PLANNING AND ZONING COMMISSION AGENDA

Monday, September 10, 2018
Ketchum City Hall
480 East Avenue North, Ketchum, ID 83340

- f. **ACTION – 760 N. Washington Mixed-Use Building Pre-Application Design Review:** 760 N. Washington Ave.: (Ketchum Townsite: Block 13: Lot 6). The Commission hear public comment, consider, and provide feedback on a Pre-Application Design Review for a new three-story, mixed-use building containing commercial/retail space and one (1) community housing unit on the first-floor and one (1) residential unit on the second and third floors.

- g. **ACTION – Felker Residence Mountain Overlay Design Review:** 255 Hillside Dr. (Lot 33, Block 2, Warm Springs Subdivision #5) The Commission will consider and take action on a Mountain Overlay Design Review Application for a single-family residence in the Mountain Overlay.

EXHIBIT D
Photographs of Creek

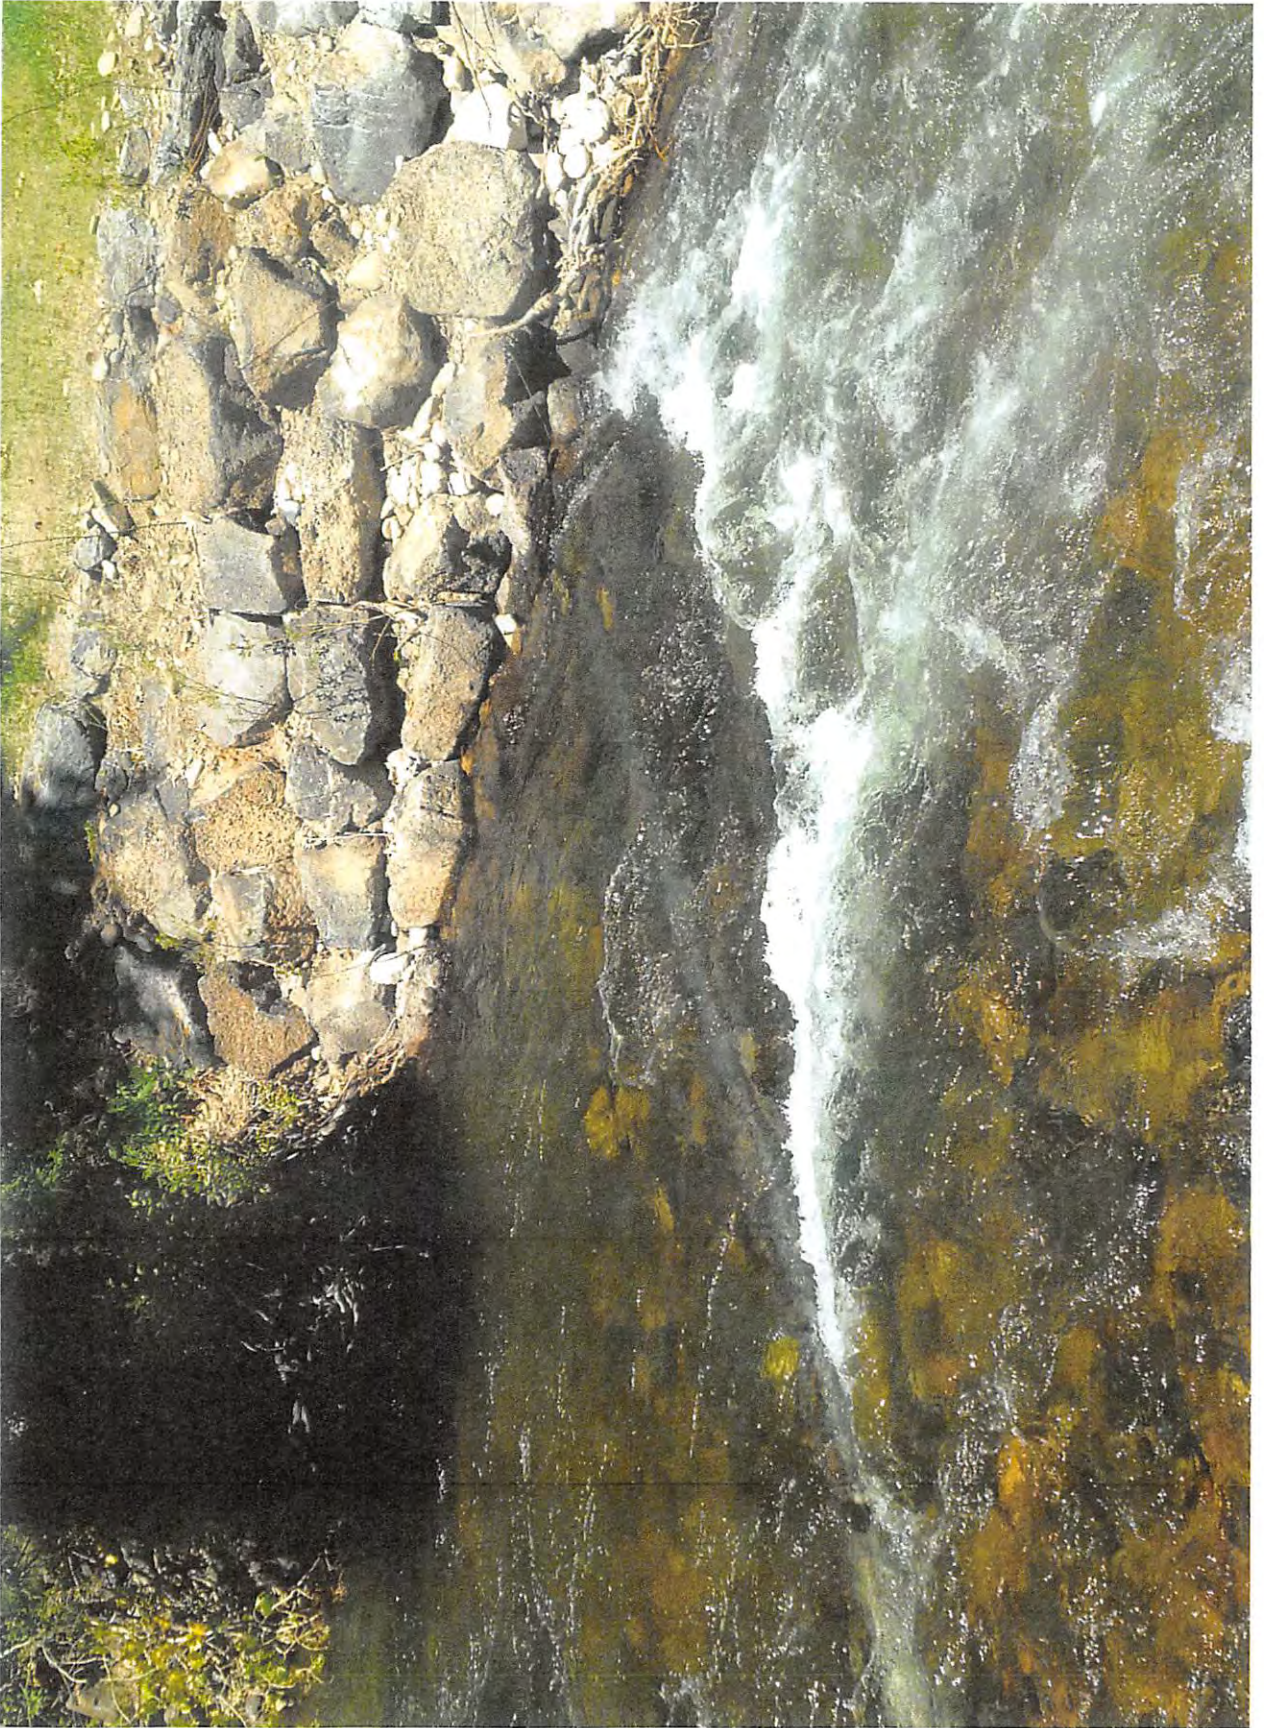
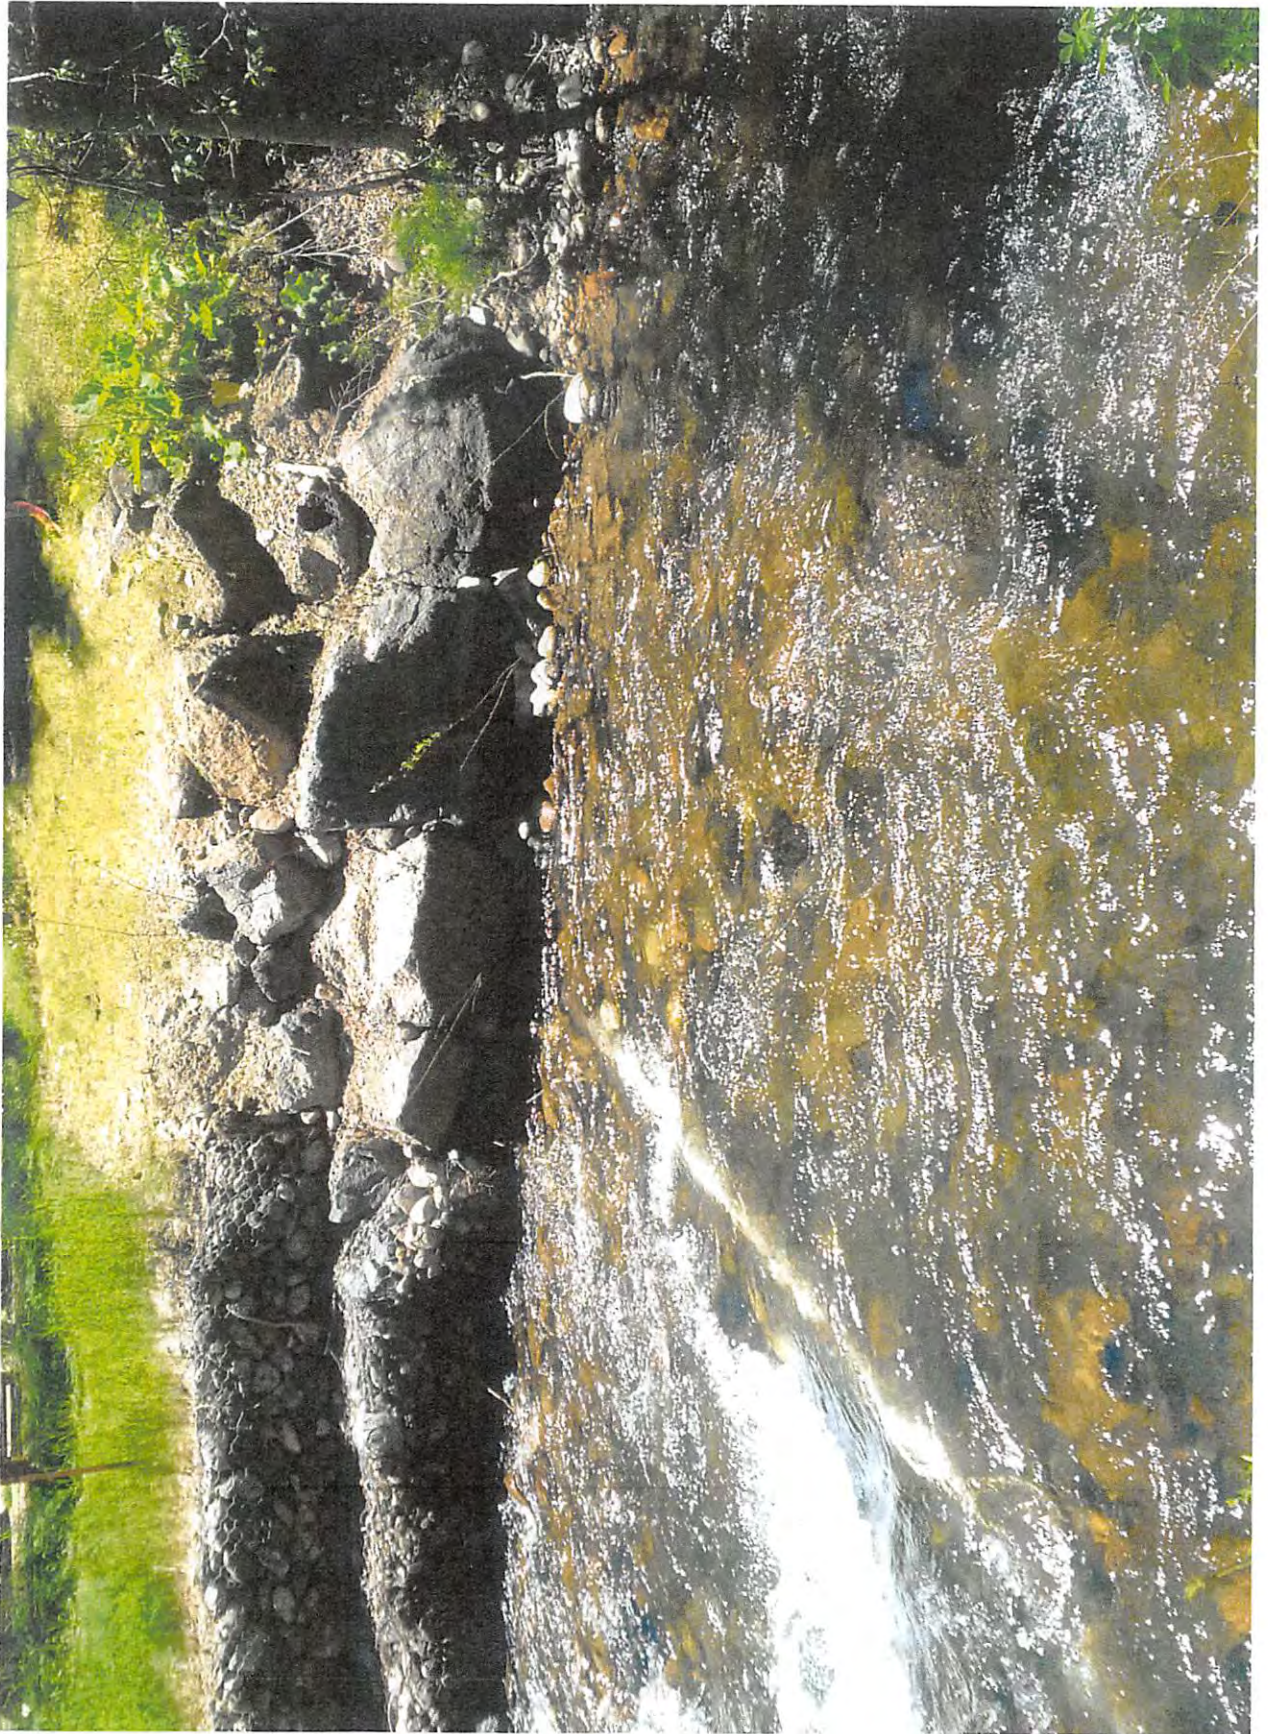
7. Photos Prove Creek Will Rise and Course Will be Altered. Attached as Exhibit D are photos of the creek. In each photo the now existing sewer main installed in 2017 can be seen. The City proposes to dump rip rap into the creek so that the rip rap traverses the entire creek. The 12" irregular shaped rip rap will extend four feet upstream of the sewer pipe and 8 feet downstream from the sewer pipe. (See Brockway Engineering, Profile and Cross-section Drawing #3.) Including the diameter of the pipe the proposed "scour pad" will create a permeable dam that exceeds 12 feet and 3 feet in height. A structure of that magnitude will most definitely cause the creek to rise and its course to be altered.
8. The Permit Allows Activity that Violates KMC 17.88.040.C.8. This code provision states:
